287/11B - PROPOSED TECHNICAL CHANGE TO RR SCHEDULE METHODOLOGY

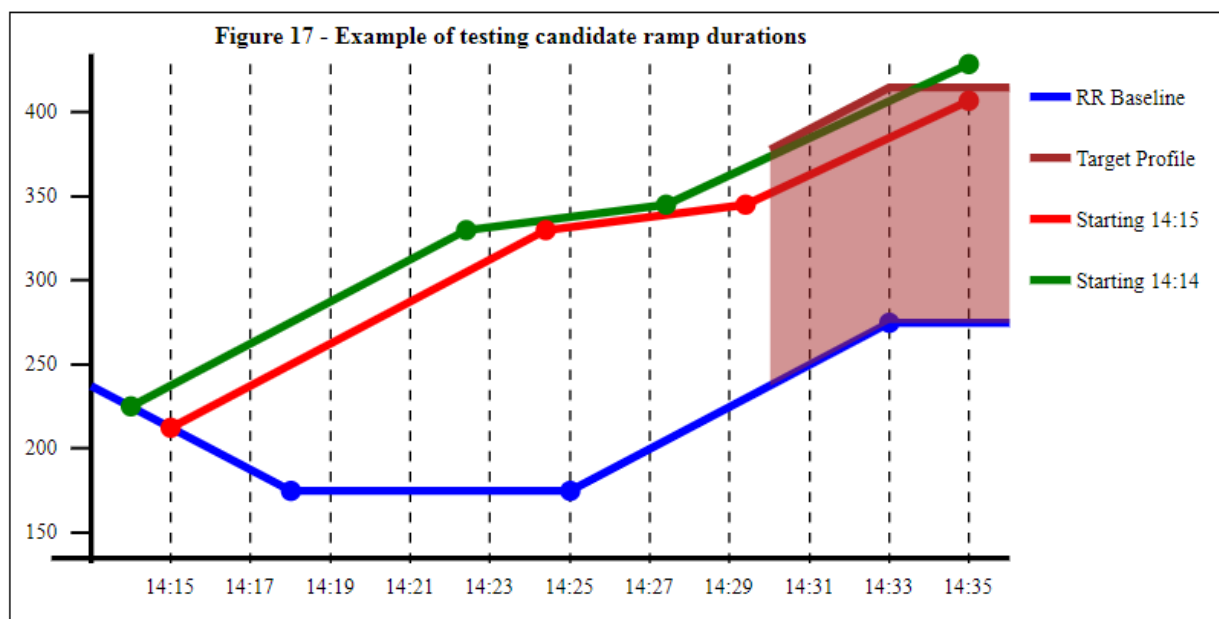
In general the RR Schedule Methodology specifies an iterative 'trial and error' approach to identifying an appropriate profile. For example, Figure 17 in the draft Methodology illustrates a candidate profile beginning at 14:15 (which does not reach the required level of 415 MW by 14:35), and another candidate profile beginning at 14:14 (which does reach the required level).

We are not proposing any change to the process for testing and identifying candidate profiles. But we are proposing a change to how the 'successful' candidate profile (i.e. the green line in Figure 17) is incorporated into the final RR Schedule:

- Version 0.2 of the RR Schedule Methodology (on which we consulted parties) proposed that the final RR Schedule would incorporate the point at which the successful candidate profile intersected the target profile (i.e. the brown line in figure 17). In the case of Figure 17, the time of intersection is approximately 14:33:40 (which would be rounded down to 14:33).

- Version 0.3 of the RR Schedule Methodology (which we are now presenting to the BSC Panel) proposes that the final point incorporated into the final RR Schedule would be the 'target' point at which we were aiming (i.e. 415 MW at 14:35, in this example).

RR Schedule Data for Figure 17			
Version 0.3 of RR Schedule Methodology (redlined against version 0.2)			
Time From	Time To	Level From	Level To
14:14	14:22	225	330
14:22	14:27	330	345
14:27	14:33 14:35	345	415

In general this change will give results that comply more accurately with the dispatch principles in the GC0097 Final Modification Report. For example, Principle IV is relevant to Figure 17, and implies that the BM Unit's ramp should meet the required level at 14:35 (five minutes into the Quarter Hour block). Version 0.3 of the Methodology more accurately achieves this.

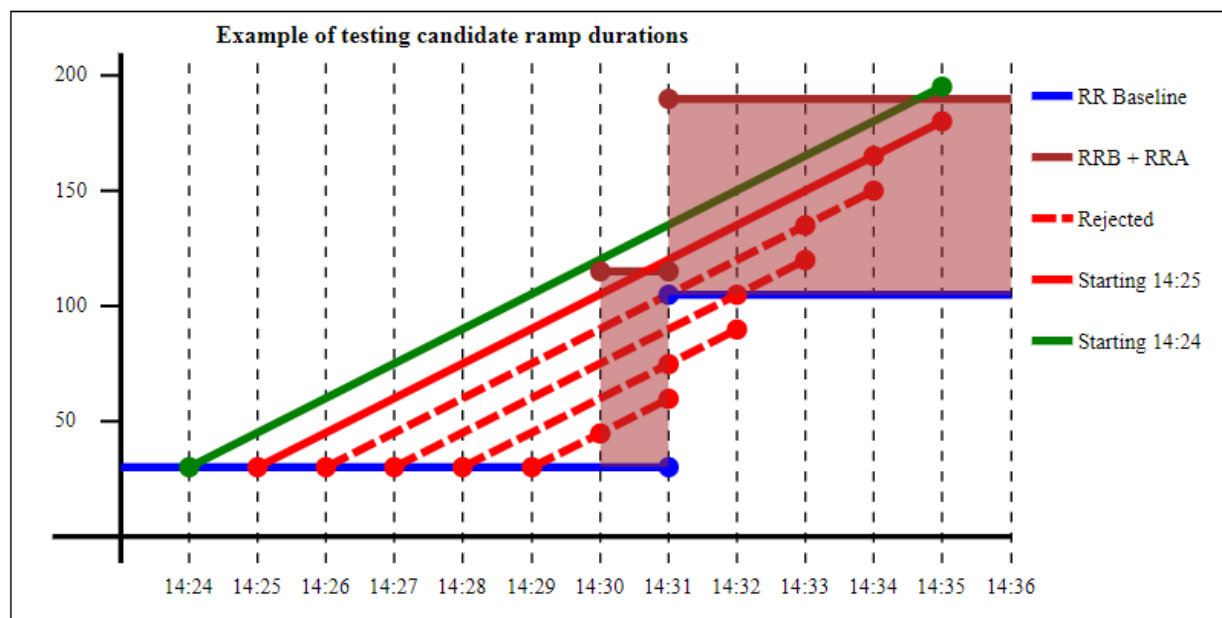
In most cases (because of the iterative process used to find candidate profiles) we would expect the difference between the two versions of the Methodology to be limited to a minute or two. But larger changes can arise if the RR Baseline is not 'well behaved' e.g. it includes a discontinuous 'jump' from one MW level to another. The following diagram provides an example of this:

- The dotted red lines are candidate profiles that don't meet the required level (i.e. the brown profile) and would therefore be rejected under either version of the Methodology;

- The solid red line is a candidate profile that does meet the brown profile at 14:30:40, but is below the required level at 14:35. This profile would be accepted under version 0.2 of the Methodology, but not version 0.3.
- The solid green line is the first candidate profile that does reach the required level at 14:35, and is therefore the first one that would be accepted under version 0.3 of the Methodology.

In this case the two versions of the RR Schedule do give significantly different RR Schedules. Under version 0.2 the profile would meet the target profile (RRB + RRA) at 14:30, and follow it from that point on:

RR Schedule Data (up until 14:36)			
Version 0.2 of RR Schedule Methodology			
Time From	Time To	Level From	Level To
14:25	14:30	30	115
14:30	14:31	115	115
14:31	14:36	190	190

While, under version 0.3 of the Methodology, the profile would continue ramping until 14:35:

RR Schedule Data (up until 14:36)			
Version 0.2 of RR Schedule Methodology			
Time From	Time To	Level From	Level To
14:24	14:35	30	190
14:35	14:36	190	190

In this instance, the results of the version 0.2 Methodology deviate more significantly from the Dispatch Principles (although, in practice, a discontinuous FPN such as this is likely to be rare for a BM Unit participating in TERRE).
